Staff Report

To: Salt Lake City Planning Commission
From: Chris Earl, Associate Planner, christopher.earl@slcgov.com, 801-535-7932
Date: July 29, 2020
Re: Detached Accessory Dwelling Unit – Conditional Use (PLNPCM2020-00092)

REQUEST: Stephen Brendle, property owner, is seeking Conditional Use approval for an Accessory Dwelling Unit (ADU) in a detached structure at approximately 1756 S Windsor Street in the R-1/5,000 Single-Family Residential zoning district. The ADU will be located above a proposed detached two-story garage which will be located in the rear yard of the property. The ADU will measure 650 square feet and the entire structure will measure a height of approximately 19 feet.

SHEET NO.
SP1

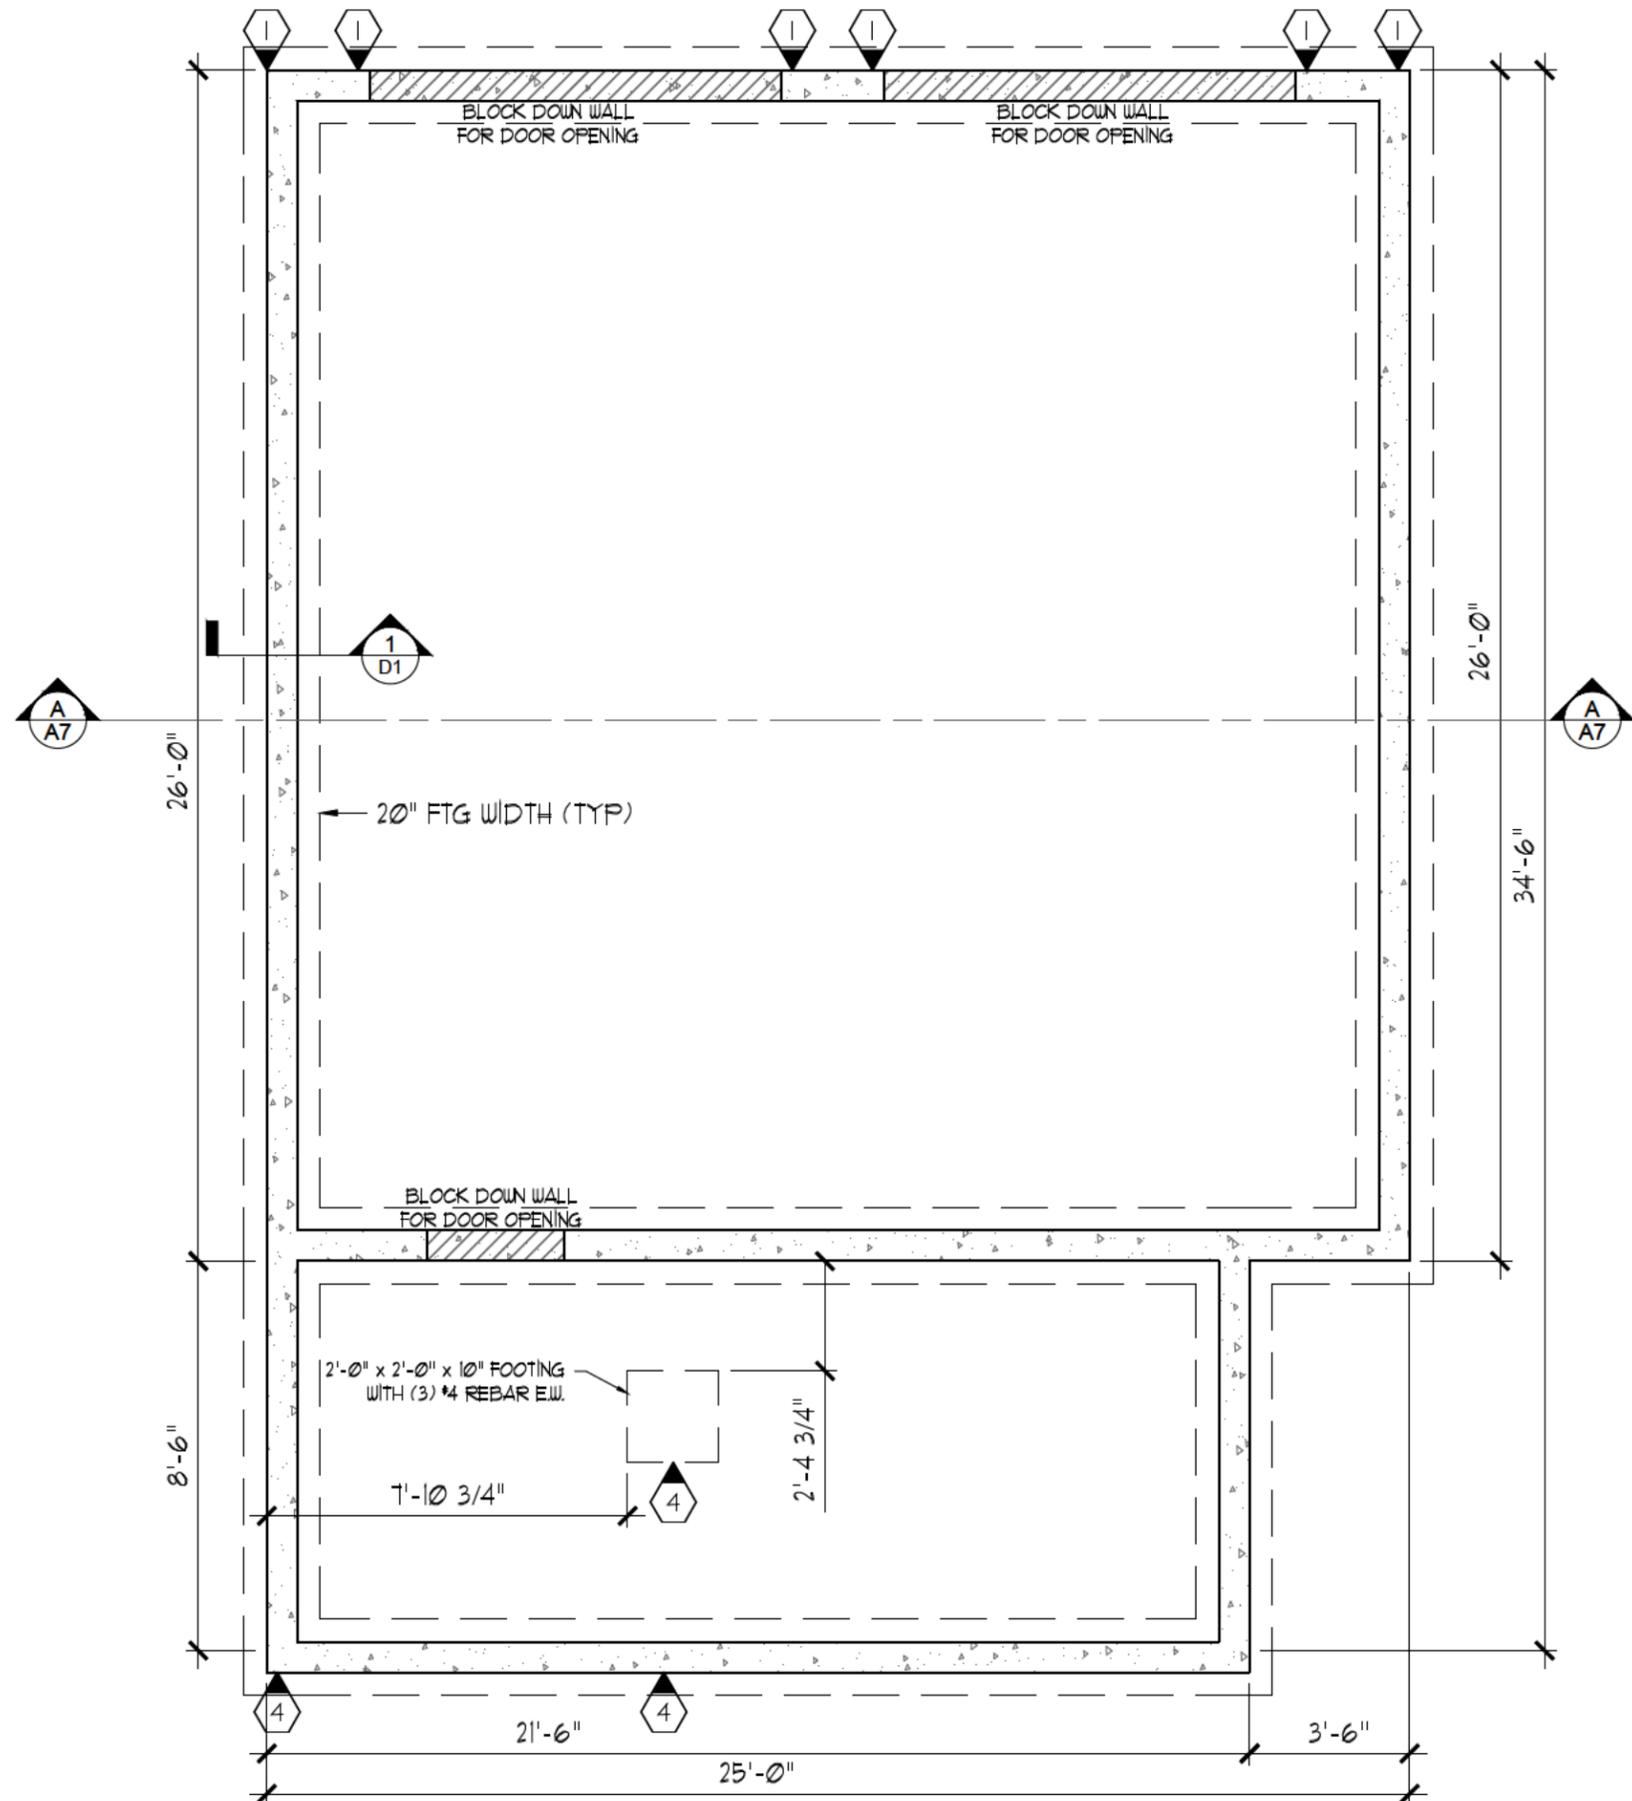
There are questions such as what is the actual height of this structure? No where on the plans show this. Also the width of the lot is 42.5' at the rear property line and not 45'. The deck takes the square footage total to above 650sq ft. No mention of landscaping around the structure.

With the rear corner property markers, we have been obliging with Mr Brendle and moved our fence on the South side 18" at the back (the front does not yet have a fence). The understanding was that he would cordially recognize that the vinyl fence would be moved to the North corner property marker. Instead he is claiming that the vinyl fence marks the property line to the north (which is Kristen's property). Kristen should be clarifying with the surveyors but the corner markers are clearly visible at the back alleyway. The distance between the rear corner markers on 1756 is 42.5' and not 45.5'.

SHEET NO.
A4

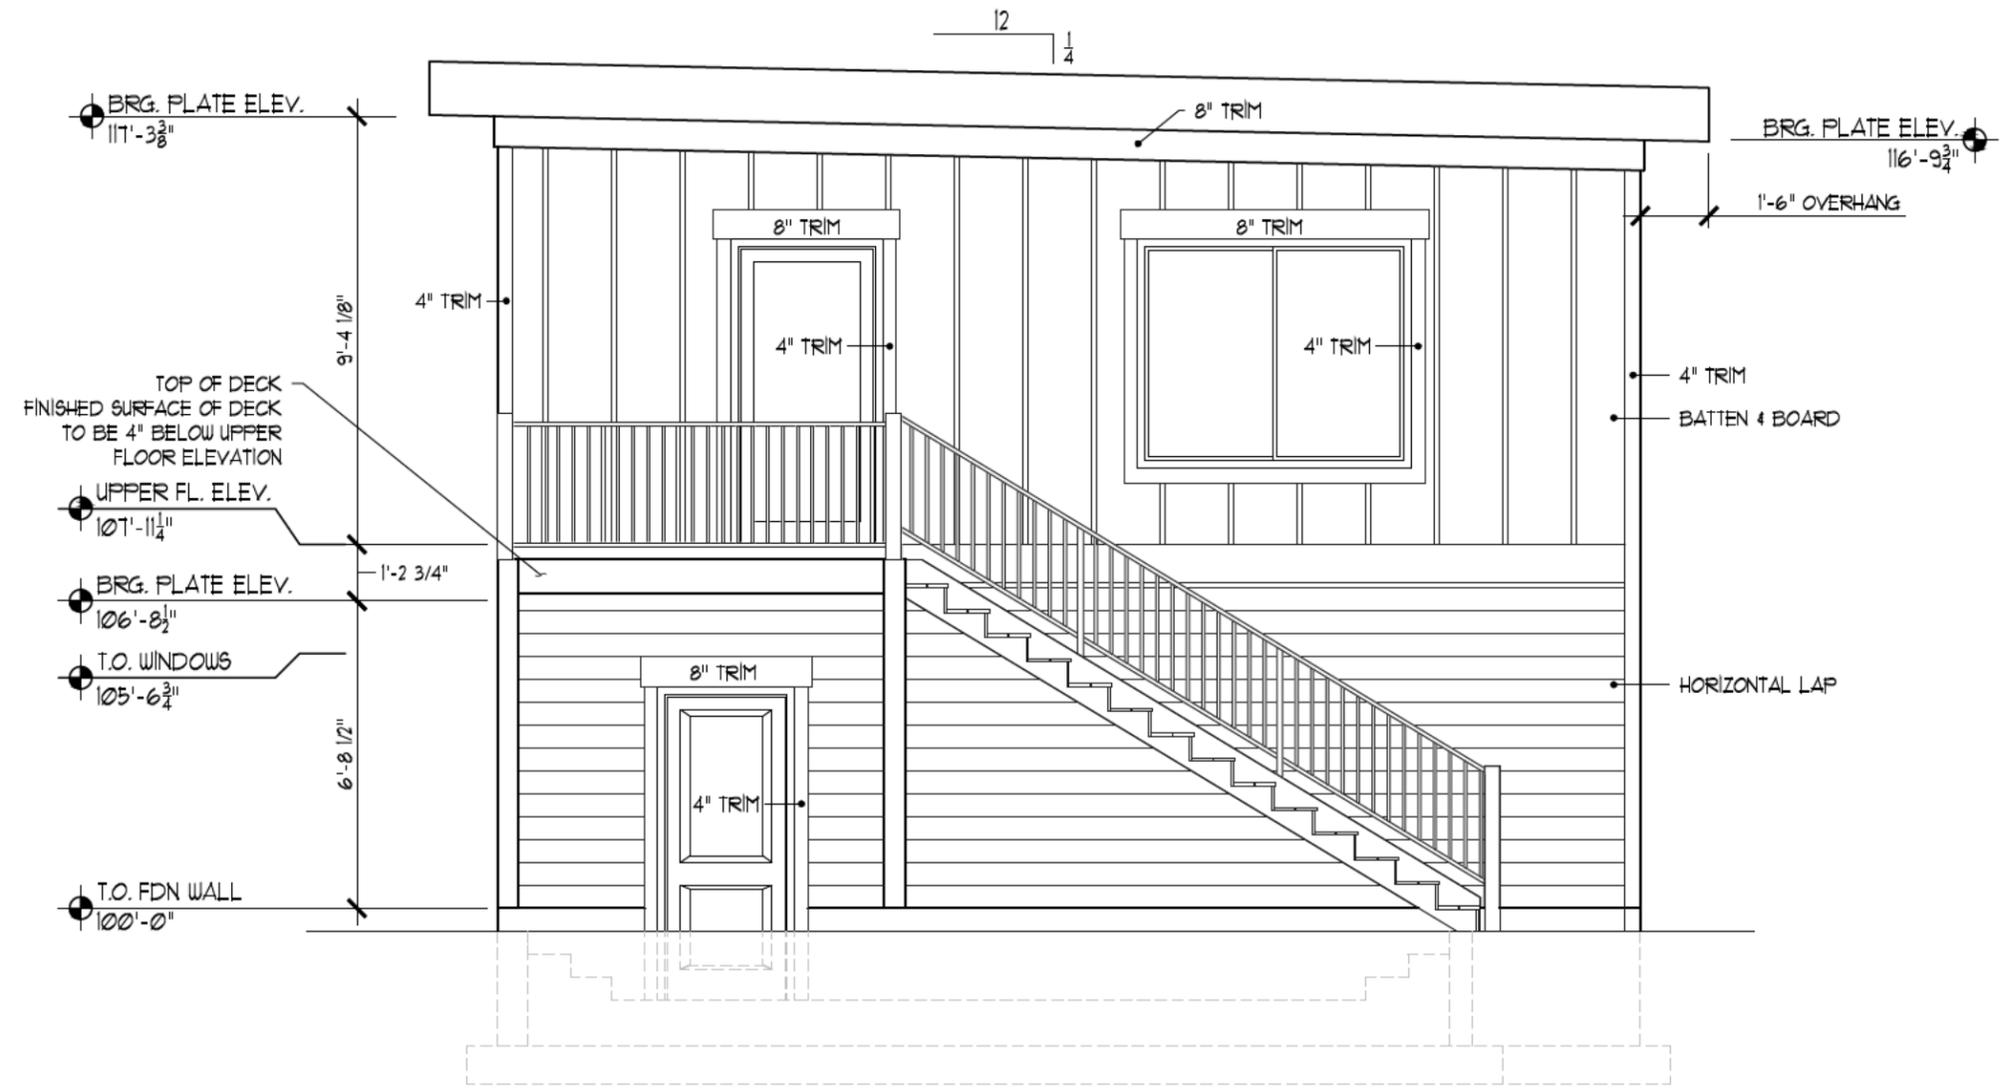
1. Need to show overall height of accessory building
2. show the dimensions & square footage of the deck leading into the front door – 80 ft.² or less?
3. sliding doors of bedroom go to where? I would assume a deck being that it is a second level ADU – need to see square footage.
